Product Change Notification

Change Notification #: 70550-1

Change Title: BCM® MX965GME Box Package Accessory – CPU Cooler Back Plate Change

Date: 4/6/2009

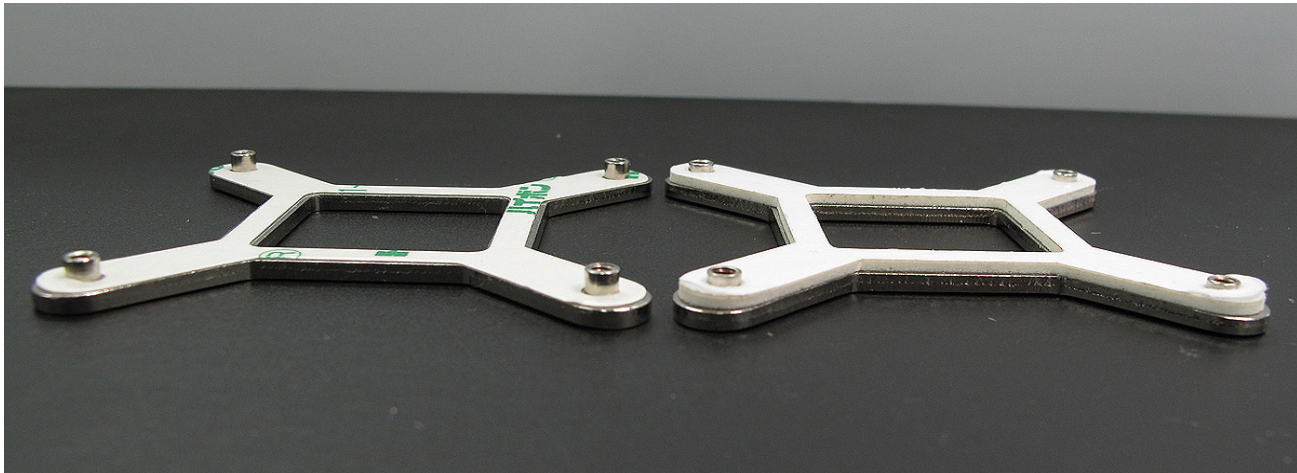
An additional foam insulator has been added to the CPU cooler back plate. This change will provide greater tolerance and help reduce the potential for a short circuit between the motherboard circuitry and the metal CPU back plate that can occur from improper installation or tightening of the CPU back plate.

BCM anticipates no impact to customers. All MX965GME box products shipped after the PCN issue date will implement this change.
